URGENT Field Safety Notice

Allura Xper, Allura Centron, and Azurion systems
Potential loss of imaging functionality resulting from no or intermittent X-ray radiation initiation through the wired foot switch.

15-August-2023

Reference: 2023-IGT-BST-004: Allura Xper, Allura Centron, and Azurion Systems.

Figure 1: AD7XT and AD7XNT Patient Table

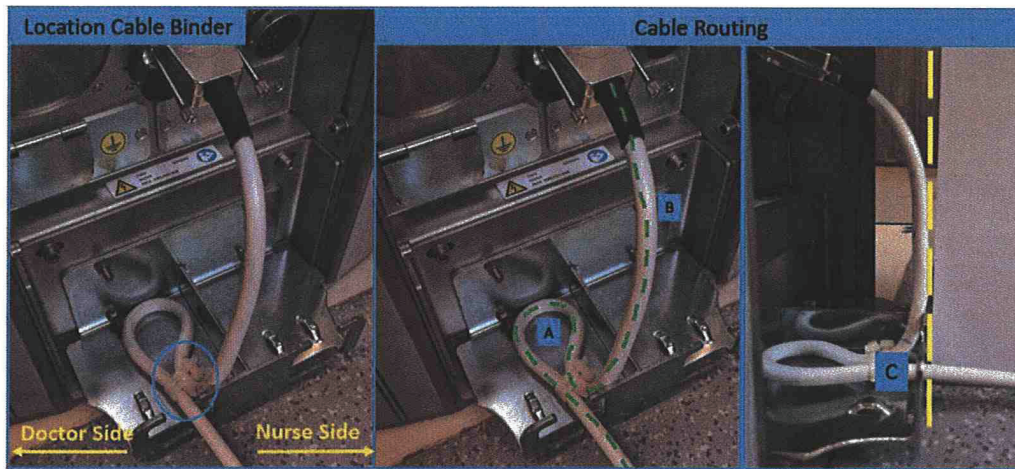
Check the strain relief and routing of the wired foot switch cable:

- Cable binder used for strain relief:
 - Type of cable binder(s)
 - Number of cable binder(s)
 - Position of cable binder(s)
- Cable routing (depending on picture indicated with "A" "B" "C")
- For AD7NT, there are 2 possibilities for strain relief:
 - Strain relief by means of bushing (Figure 4a)
 - Strain relief by cable binder (Figure 4b)
- For correct routing and strain relief, see Figures 1-6 below.

Number of cable binder(s): 2 (two)

If strain relief or routing is not correct, repair according to the repair instructions.

Figure 2: AD7XT and AD7XNT Auxiliary OP Rail Patient Table Strain Relief

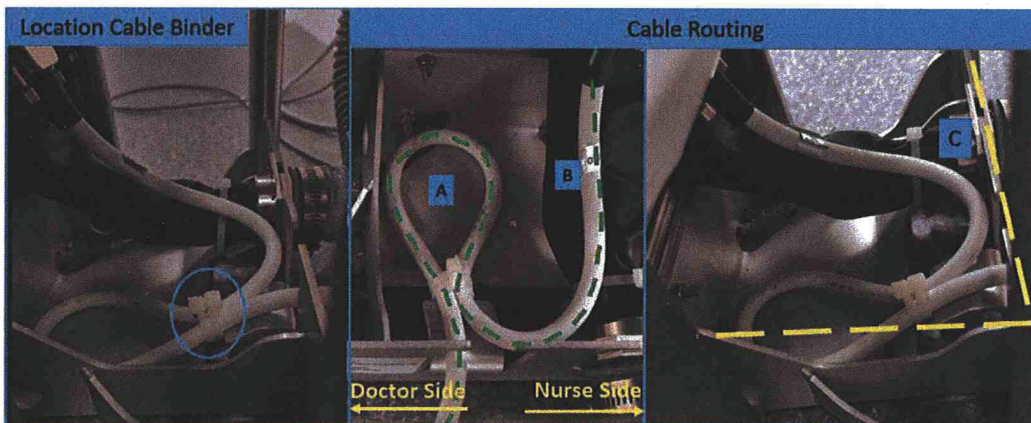
Number of cable binder(s): 2 (two)

Figure 3: AD7 Patient Table

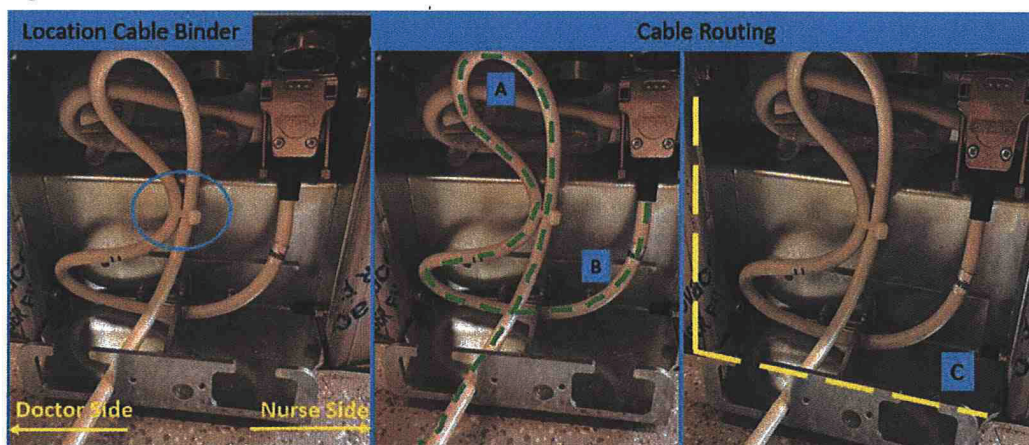
Number of cable binder(s): 1 (one)

Figure 5: Pedestal Wall Connection Box

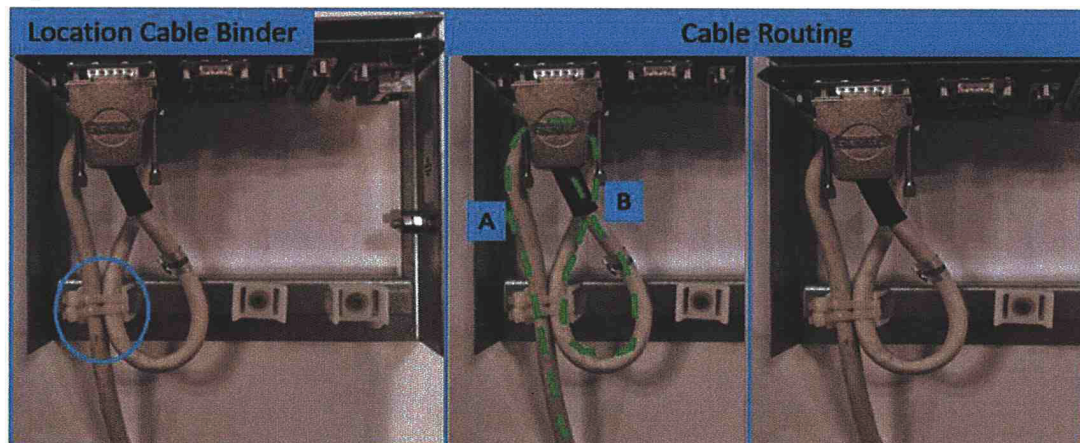
Number of cable binder(s): 2 (two)

Figure 6: Surgery Wall Connection Box

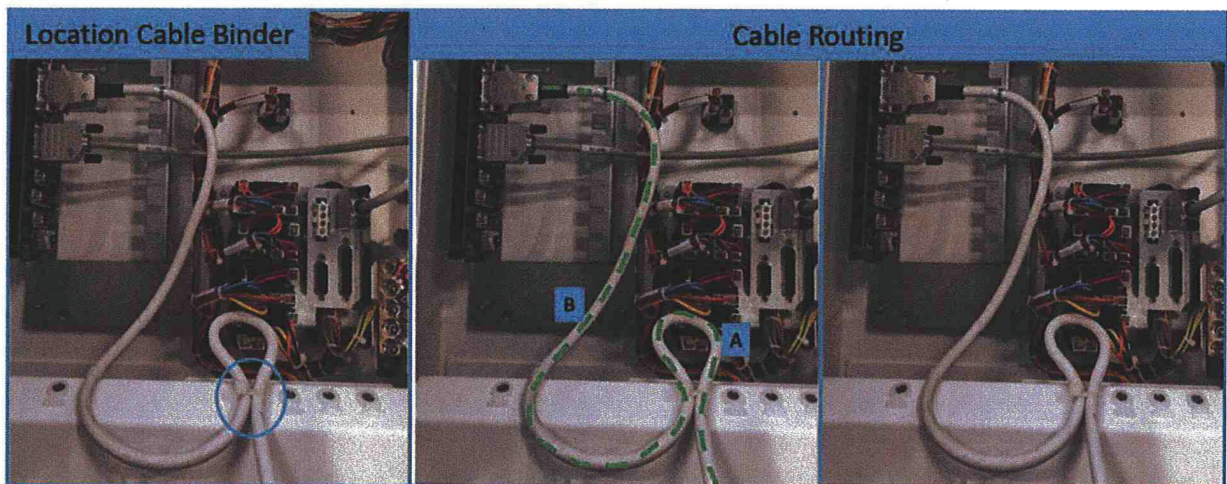
Number of cable binder(s): 1 (one)

Figure 8: Swivel table (AD7NT, AD7XT and AD7XNT)

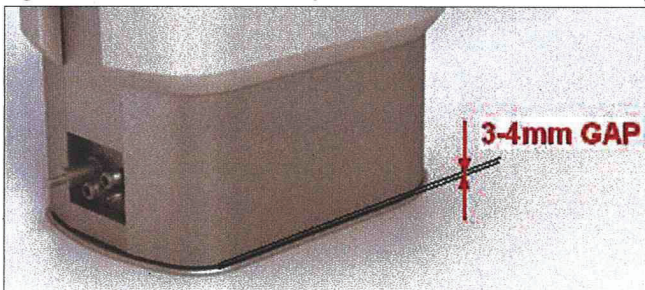
Check the clearance of the plinth cover:

- For a non-swivel table
 - Make sure that the clearance to the fluid protection plate is 3-4 mm
 - Refer to Figure 7
- For a swivel table
 - Make sure that the clearance to the swivel cover is 3-4 mm
 - Refer to Figure 8

If the gap between the plinth covers and the floor does not satisfy the above requirement, adjust the plinth cover according to the repair instructions.
